***Substation Rebuild at Kenora MTS  
Notification of Conditional Approval of Connection Proposal  
CAA ID# 2009-EX434***

**ASSESSMENT SUMMARY**  
**Kenora Hydro**

**1.0 GENERAL DESCRIPTION & PROPOSED MODIFICATIONS**

Figure 1 – Kenora MTS Future Configuration

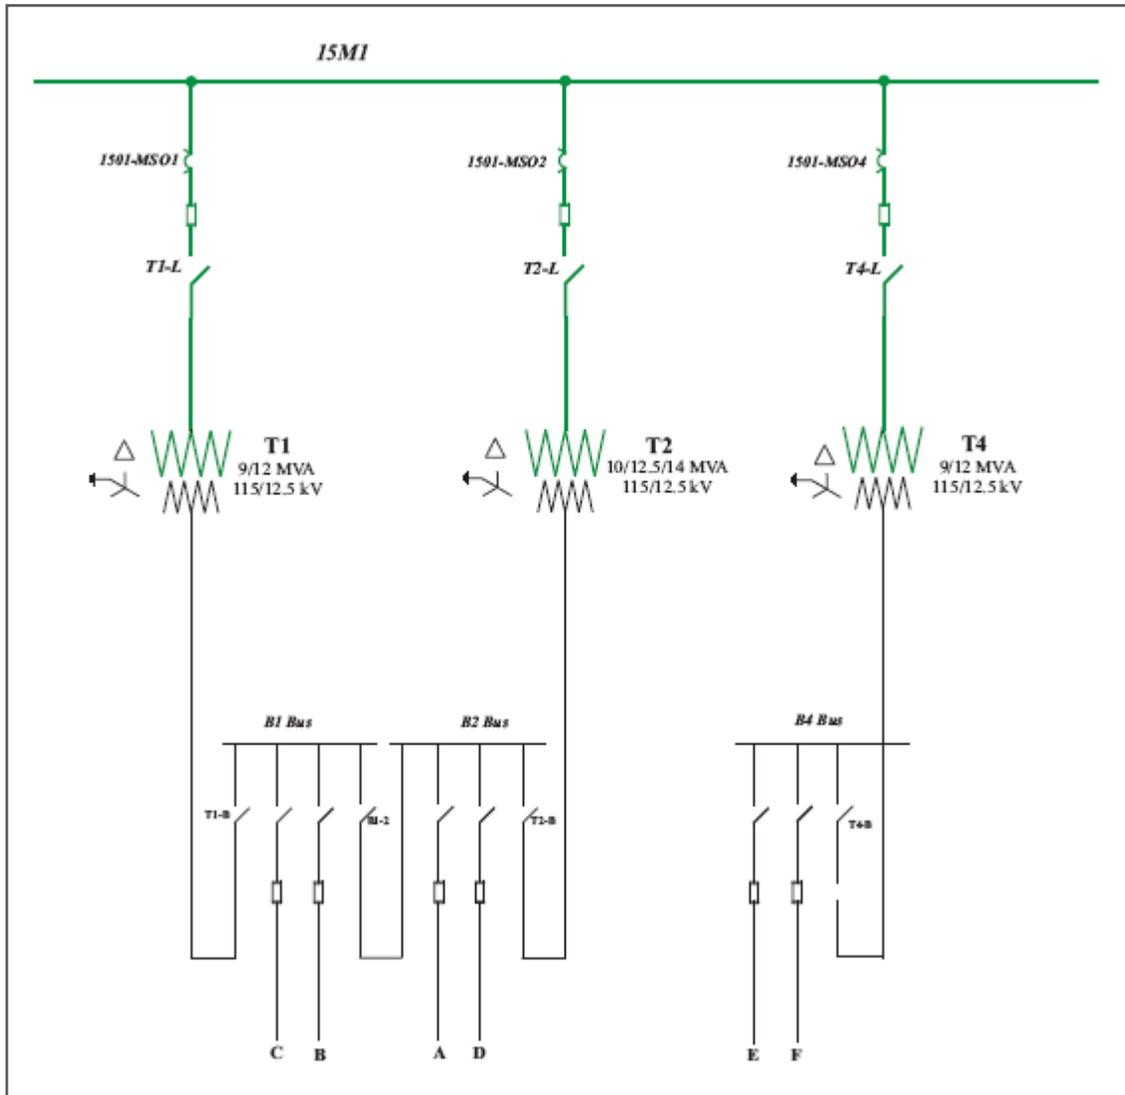
Kenora Hydro is planning to replace the existing T3 transformer at Kenora MTS with a new T4 and a new disconnect switch. The expected in-service date is June 2009.

Kenora MTS is fed from the 115 kV circuits 15M1 from Rabbit Lake TS. The new configuration of Kenora MTS is shown in figure 1 below.

The replacement transformer T4 is identical to the existing T1 transformer and very similar to T2.

The new disconnect switch will meet the short circuit requirements and the maximum voltage requirements stated in section 3.

This expedited System Impact Assessment concludes that the installation of the new transformer T4 in place of the end of life T3 and the new disconnect switch at Kenora MTS is not expected to have a material adverse impact on the IESO-controlled grid.

Appendix 4.1, reference 2 of the Market Rules states that equipment on the 115 kV grid in the north may be exposed to voltages as high as 132 kV. In addition, some recognized contingencies (e.g. load shedding, open line end) can cause a temporary voltage increase above the maximum continuous voltage. For these conditions, connection equipment may be exposed to voltages approximately 5% above the maximum continuous operating voltage for the period of time that it takes the IESO to direct operations to restore a normal voltage profile and to prepare for the next contingency. This reparation period will be as short as possible but it should not take longer than 30 minutes. Therefore, the IESO requires that 115 kV connection equipment in northern Ontario:

- must have a maximum continuous voltage rating of at least 132 kV; and
- must be able to sustain operation at voltages up to 139 kV for up to 30 minutes.
